# Access Compliance Report

## Public Rights-of-Way

Intersection ID: 20639	Main Street: CROWN_VIEW_DR	Cross Street: TOWER_POINT_DR	Location:	N
ADA ID: C9AD84297419	Ramp Type: PerpDiag	Initial Pass/Fail: Fail	Overall Compliance: No	Severity Score: 12.5

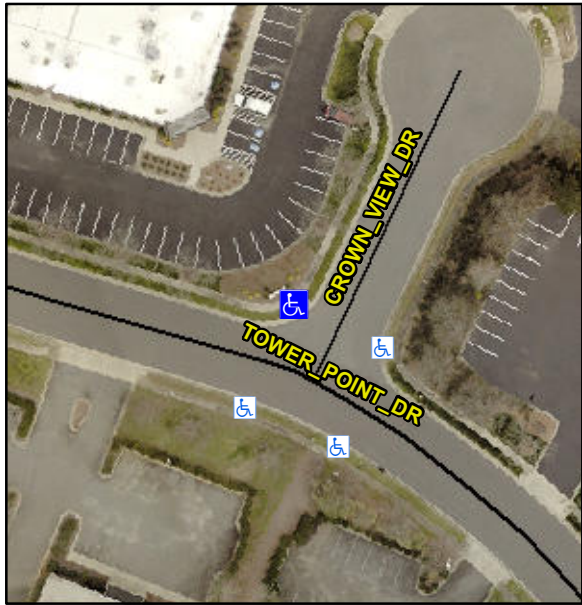
Codes/Mitigation Info/Possible Solution			Field Measurements/Component Compliance					
	Possible Solutions:		Compliance	Description	Data	Compliance	Description	Data
	Remove & Replace Curb Ramp With Two New Directional Ramps or Equivalent.		N/A	Ramp Length (in)	63.5	Yes	Ramp Slope (%)	5.4
			Yes	Ramp Width (in)	51.0	No	Ramp XSlope (%)	5.2
			N/A	Flare Type LT	N/A	N/A	Flare Type RT	N/A
			N/A	Flare Slope LT (%)	N/A	N/A	Flare Slope RT (%)	N/A
			N/A	Flare Traversable LT?	N/A	N/A	Flare Traversable RT?	N/A
			N/A	Landing Length (in)	N/A	N/A	DWS Provided?	N/A
			N/A	Landing Width (in)	N/A	N/A	DWS Contrast?	N/A
			N/A	Landing Slope (%)	N/A	N/A	DWS Length (in)	N/A
			N/A	Landing X Slope (%)	N/A	N/A	DWS Full Width?	N/A
Surveyor Notes:		N/A	N/A	Landing Curb? (Y/N)	N/A	N/A	DWS Offset (in)	N/A
			N/A	Shared Landing?	N/A			
PROW/ADA:		Not Found, R304.5.3	N/A	Gutter Ponding?	N/A	N/A	Gutter Slope (%)	N/A
			N/A	Gutter Lip Ht (in)	N/A	N/A	Gutter X Slope (%)	N/A

N/A	Painted X Walk1?	No	N/A	Painted X Walk2?	No
				X Walk 1 Direction	To SW		X Walk 2 Direction	To SE
			N/A	X Walk 1 Width (in)	N/A	N/A	X Walk 2 Width (in)	N/A
				X Walk 1 Slope (%)	5.2		X Walk 2 Slope (%)	6.5
				X Walk 1 X Slope (%)	2.2		X Walk 2 X Slope (%)	3.5
			N/A	Ramp inside XWalk1?	N/A	N/A	Ramp inside XWalk2?	N/A
				Road Slope (%)	1.3	N/A	Clear Space?	N/A
				Road X Slope (%)	3.2	N/A	Clear Space to XWalk (in)	N/A
			N/A	Any Obstructions?	N/A	N/A	Storm Grate/Utility Hazard?	N/A
				Obstruction Type			Storm Grate/Utility Type	
					N/A			N/A
						Yes	Surface Condition? (G/P)	Good
